15, 8-13, Free Town Cr.

ORDER UNDER SECTION 96 (2) OF ACT, III OF 1901.

PROPOSED BUNGALOW ON PLOT NO. 15 SHEET NO. J. I. B.

FRERE TOWN QUARTER.

GROUND FLOOR PLAN

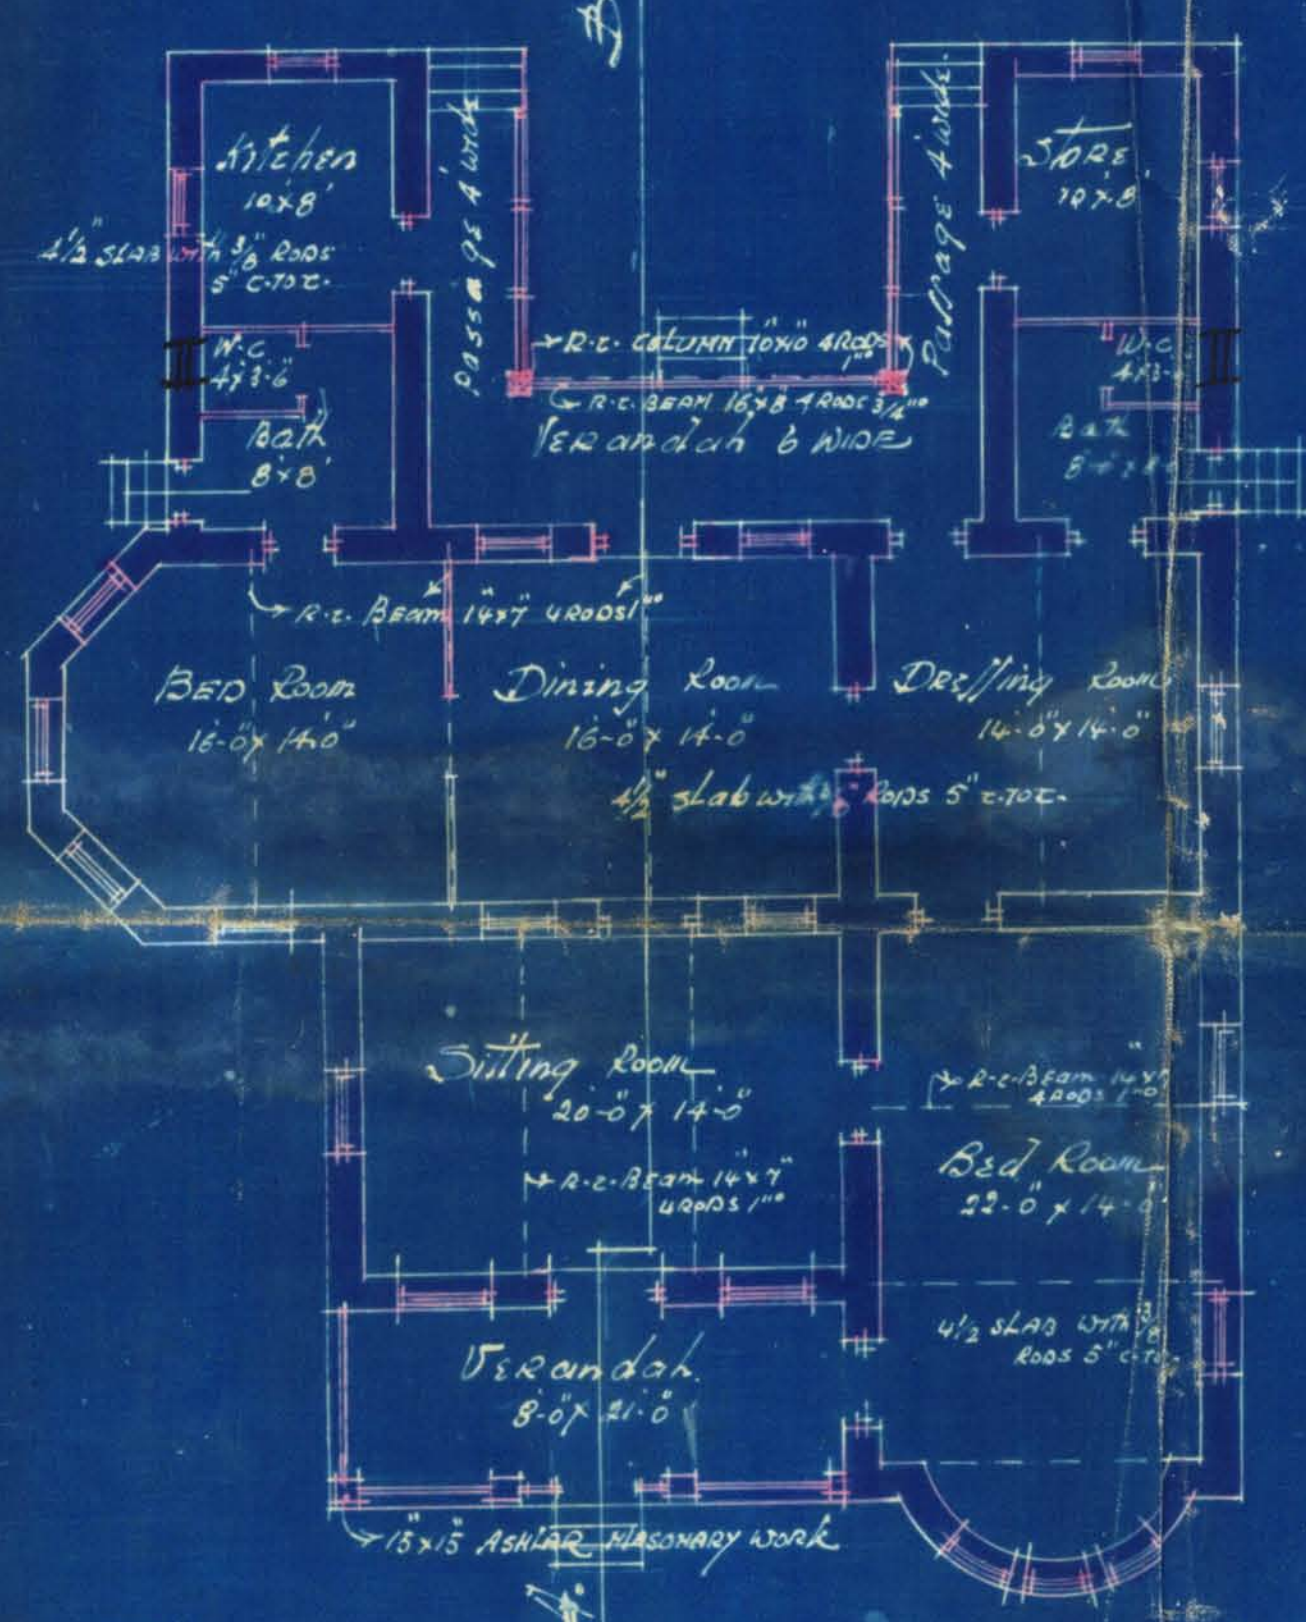
- (1) Requirement no(4) of this office no. 12700 of 15.10.28
- (2) is not fully complied with. The distances from the corners of the out house to the boundary of the plot is not marked on the side plan. According to land rules no construction should be proposed nearer the street than 10'
- (3) This correction could be done in this office by any
- (4) one deputed for the purpose
- (5)
- (6)
- (7)
- (8)
- (9)

- (1) Managing Committee's sanction will have to be obtained
- (2) for allowing two bungalows on one plot, for according to the land sale rules ^{this is} ~~they are~~ not allowed.
- (3) The applicant's name does not appear in the Land Registry ~~But that of~~. He will have to produce the title deed.
- (4) The area covered up by buildings and that left open must be given on the plan.
- (5) The distances of the proposed structures from the boundary of the plot must be marked on the site plan, and also the area of the plot.

(4) The distances of the proposed structures from the boundary of the plot
must be marked on the site plan.

Plans corrected.

With reference to your memo No.L.M.A.12700, dated 15th ultimo, we beg to return here-with the plans duly amended.
